Zoning Board of Appeals Meeting
Wednesday, May 29, 2019 at 7:30 pm
Sanford Hall
155 Village Street Medway, MA 02053
Meeting Minutes

39 Main Street Comprehensive Permit Application – (Continued from May 15, 2019) The Applicant SLV Medway, LLC seeks a Comprehensive Permit under MGL c. 40B, Sections 20 – 23 as amended, to allow construction of a 190-unit complex called “39 Main” in which 25% of the units (48 units total) will be affordable. The complex will be located on a 12.3-acre parcel in the Agricultural Residential I (AR-I) district of Medway, MA.

Ref: 39 Main Street
40B Site Plan Review
Tetra Tech Review

Second to Fourth Floor Plan 39 MAIN STREET - MEDWAY, MA

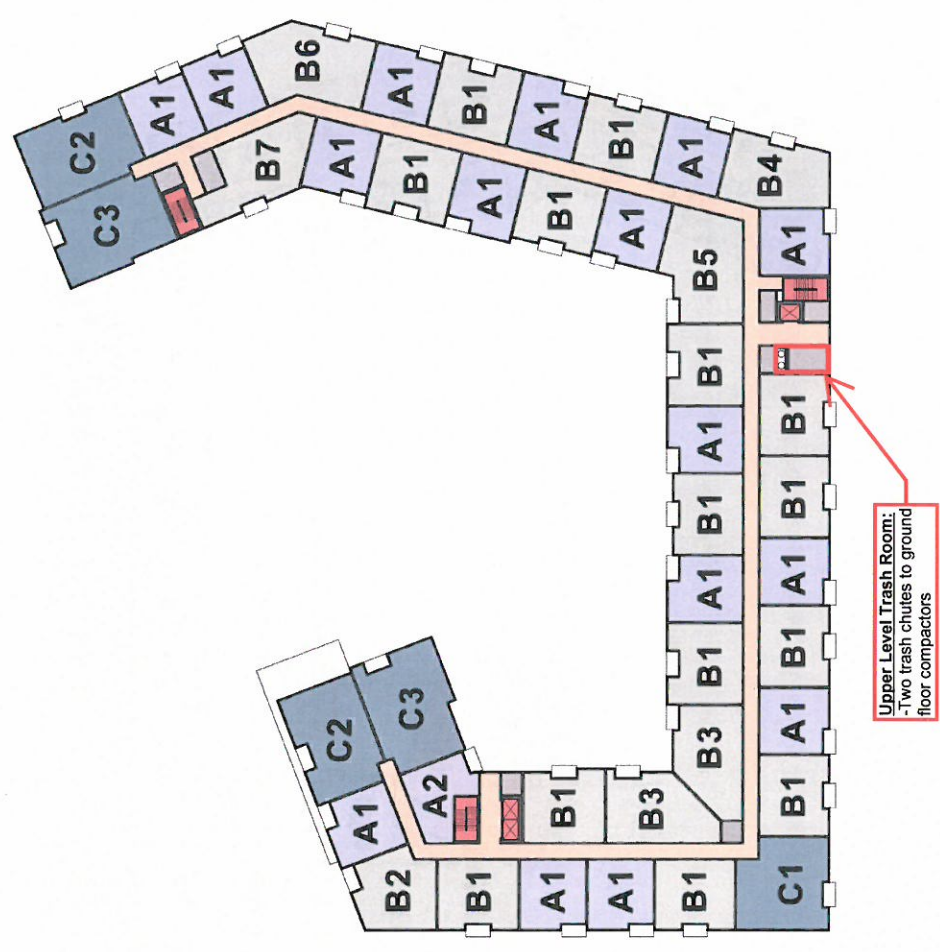
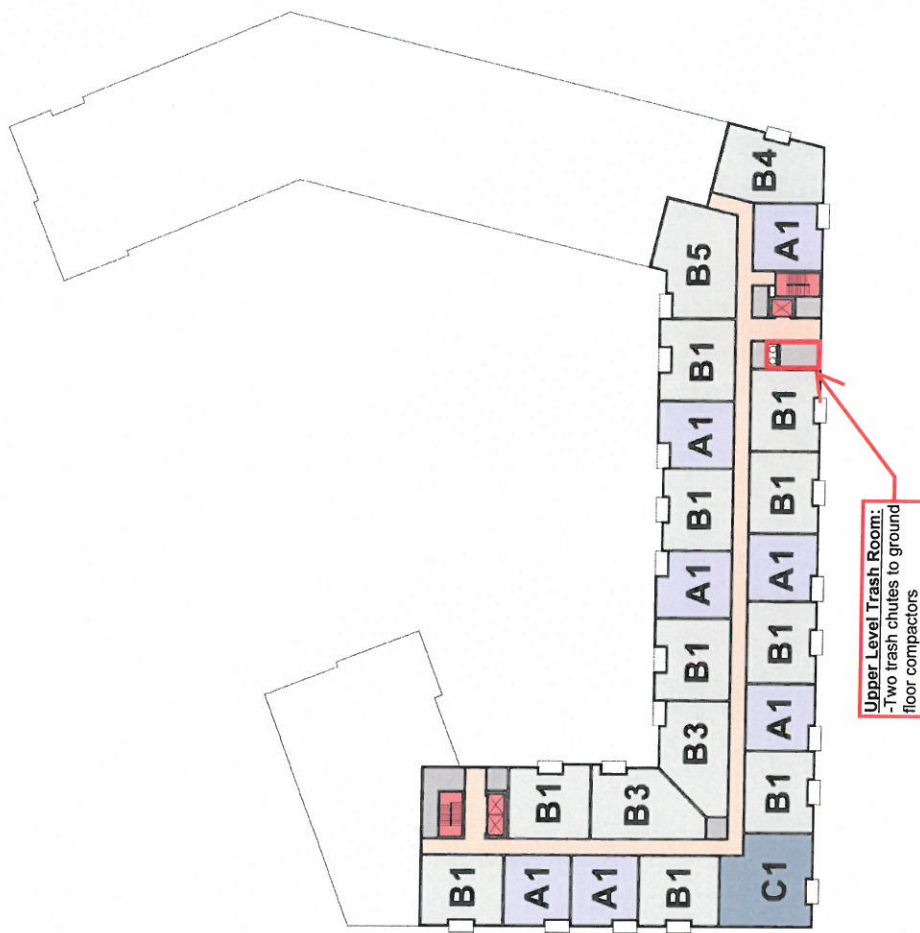
Mr. Engler also had floor plans showing the locations of trash receptacles and bicycle racks. There will be one internal bicycle storage area in the building and other external bike racks located on the property. He discussed that trash would all be handled internally in the building via trash chutes and compactors. The loading area is located to the back of the building, which is where the trash would be picked up on “trash day” and would be handled by building management.

39 MAIN STREET
LAYOUT
PLAN OF LAND
IN
MEDWAY, MA

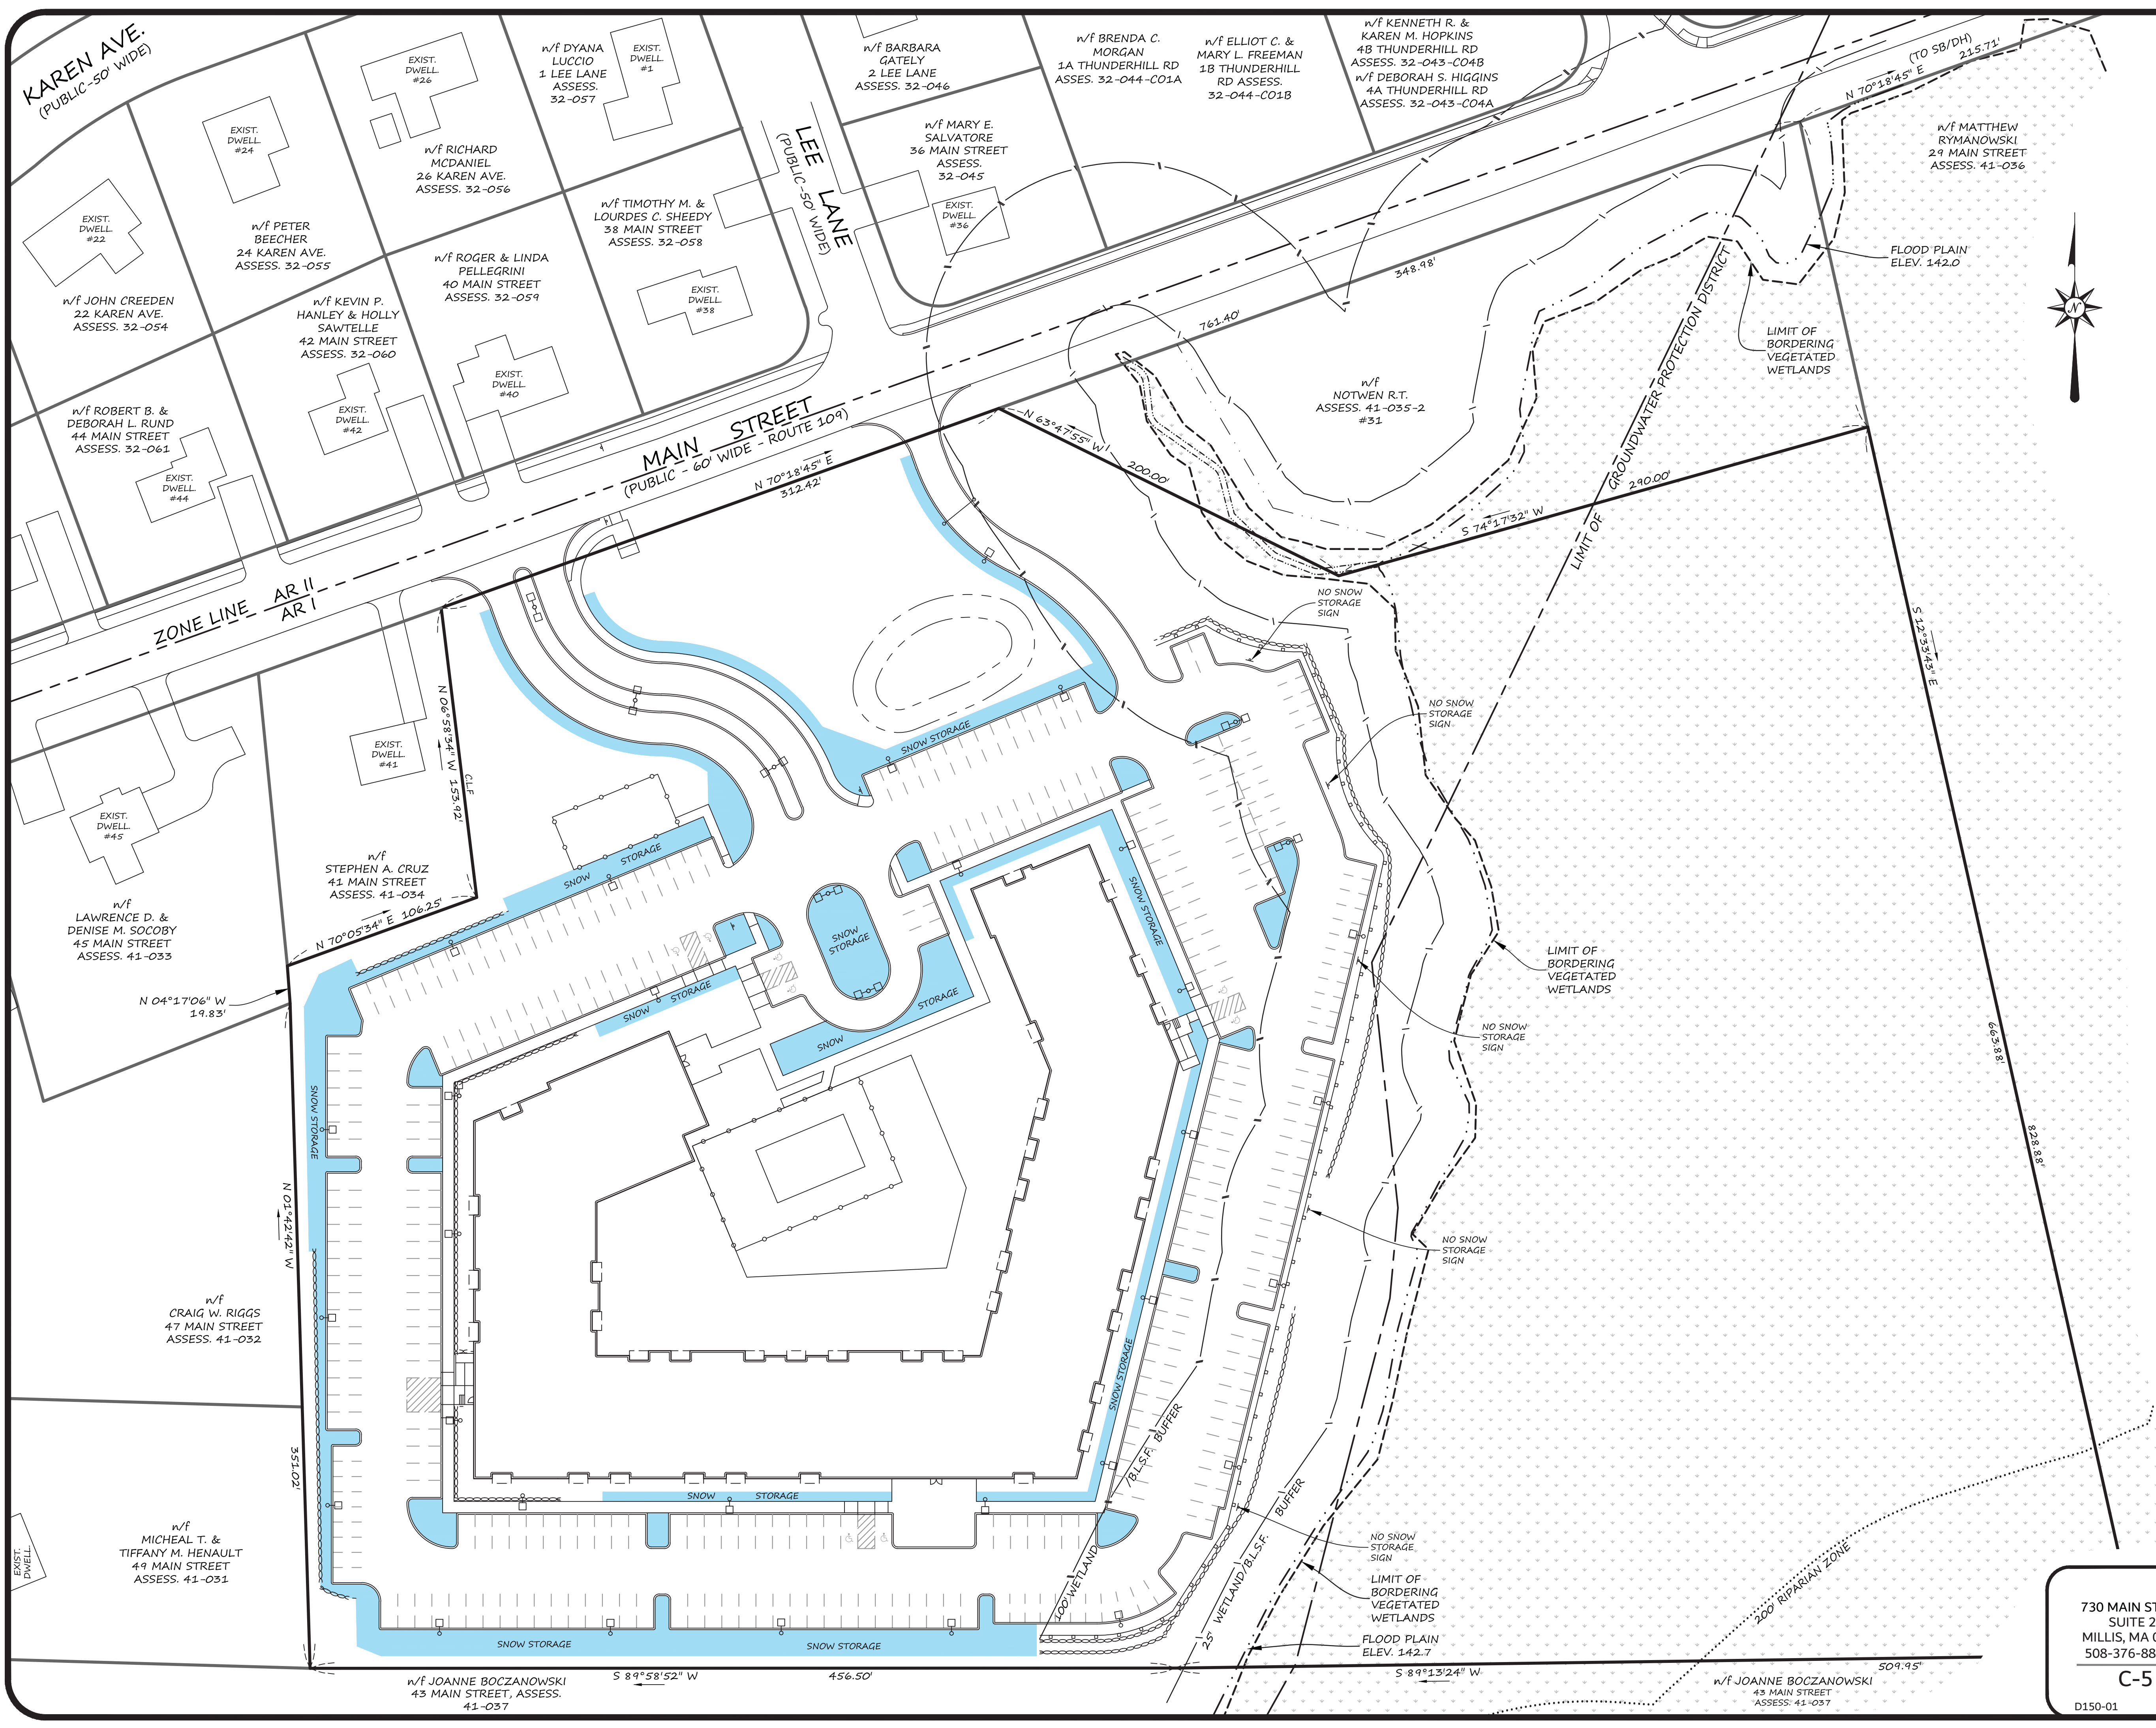
Mr. Merrikin then referenced page C-4 of the new site plans and discussed the Fire Department's request for one gate on their emergency entrance and change of the "roundings" to facilitate safe and adequate fire truck turning and maneuvering.

Mr. White questioned if they have taken the widest turn radius of all of the fire trucks into account and requested they double check with the Fire Department regarding this issue to make sure the plans meet this requirement.

4. *Comment: The applicant has proposed a boulevard entrance with two 16-foot lanes used for entrance and exit. NFPA requires 20-foot minimum lane width. We recommend the applicant confirm with Medway Fire chief regarding lane width and ensure Medway Fire Apparatus can navigate through the site and shall provide plans of proposed swept path of emergency vehicle(s) as required by the Fire Chief.*

7. *Comment: Gates have not been shown on the Plans at the proposed fire lane to limit access to emergency vehicles only. A detail of the proposed gate(s) should also be shown with provisions for fire department access.*

Response: The applicant has met with the Fire Department on several occasions, most recently on May 21st. The Fire Department has indicated to us that the proposed design is satisfactory. A fire truck turning movement plan is attached. The corner roundings on at the intersection of the boulevard driveway and parking areas were increased to 25' radius to facilitate truck movements.

Response: The fire department requested a single gate approximately 60 feet back from the street. This has been added to sheet C-4 along with a detail on sheet C-10.

Response: Refer to responses by Vanasse & Associates, Inc. dated May 14, 2019. Sight triangles as determined by the traffic consultant have been added to sheet C-4.

39 MAIN STREET
SNOW STORAGE
PLAN OF LAND
IN
MEDWAY, MA

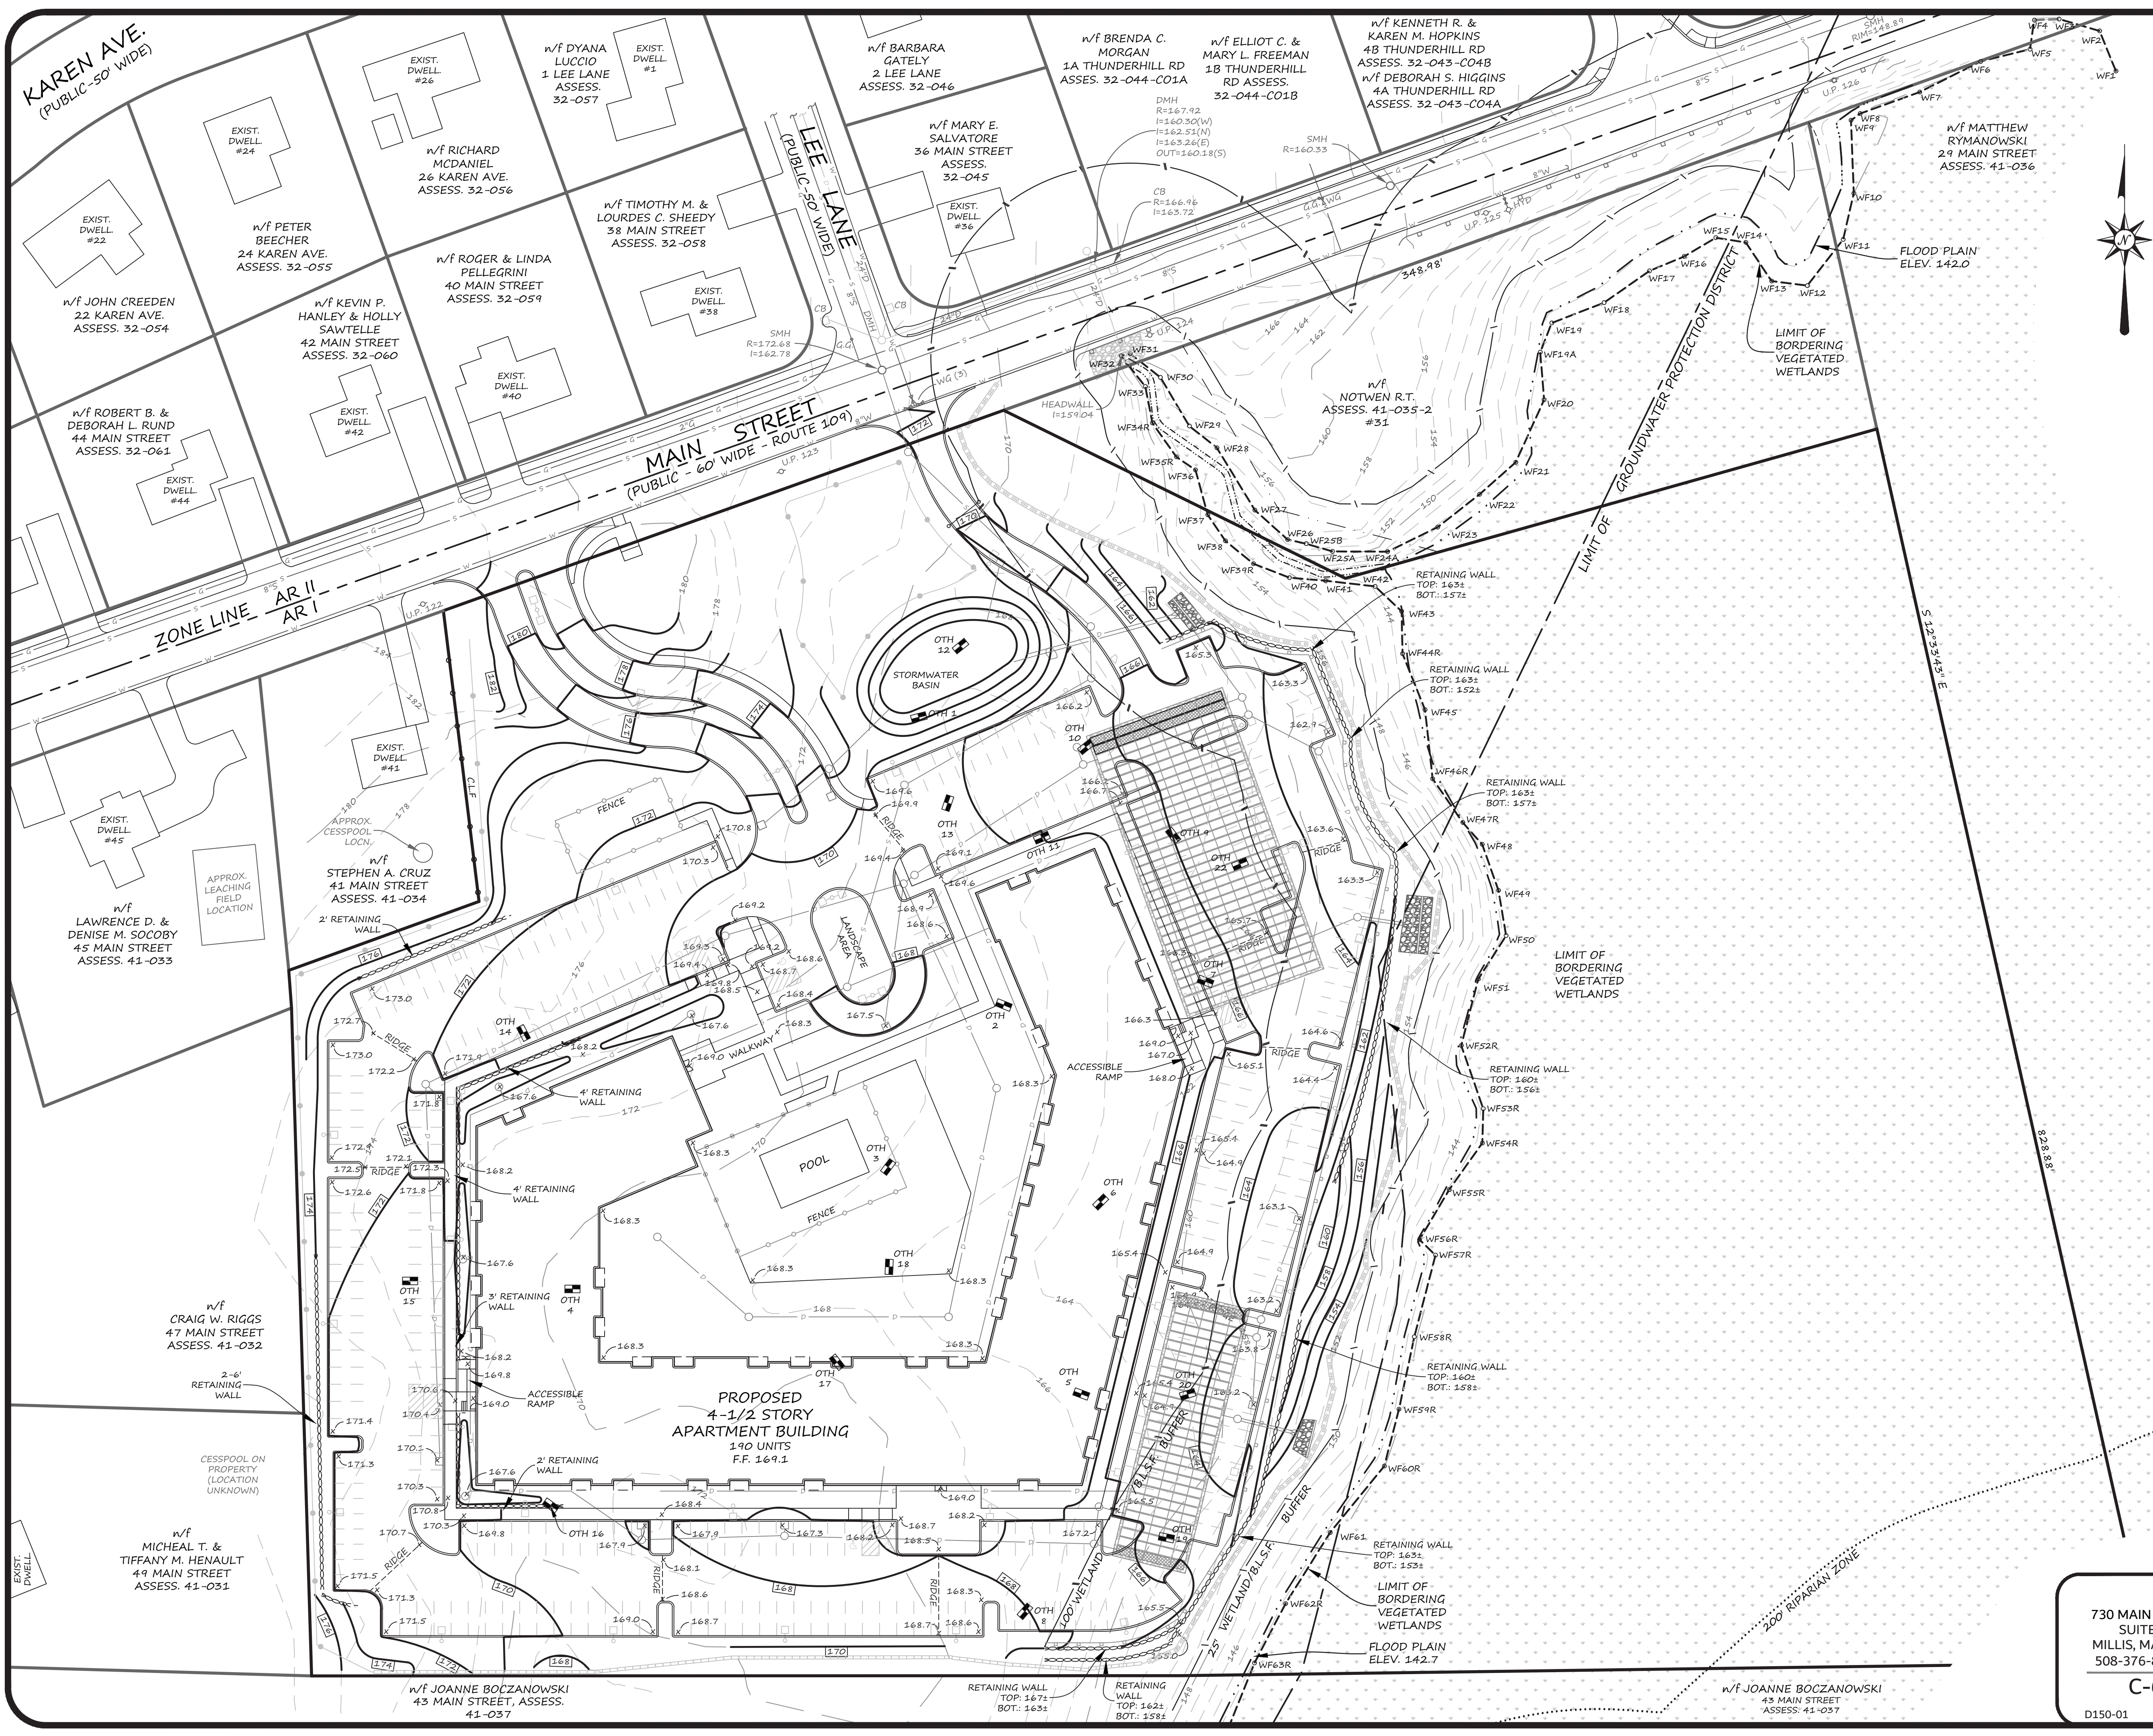
Mr. Stumpf then started to discuss snow removal and that he felt that it is not adequate. Mr. Merrikin stated discussed the team needing to talk to the landscapers about snow management, and they need to work with the Conservation Commission which wants them to preserve wooded areas, which impacts available space for snow management. The issue of the cars having to move regarding snow removal will be the responsibility of building management. There was then a discussion around the lighting improvements referenced on page C-9 of the new site plans and that the improvements eliminate lighting “spill” onto abutting properties.

5. *Comment: Proposed snow storage does not appear to be sufficient. Furthermore, snow storage is proposed along the building faces which may cause impacts to proposed light poles, sidewalk and landscaping. We anticipate the need for off-site removal of snow in a majority of snow events.*

Response: A separate snow storage plan has been included in the revised site plan. It is recognized that off-site removal may be required for significant storms events. This plan will be refined further as the landscape plan is modified and will be updated again on a subsequent revision.
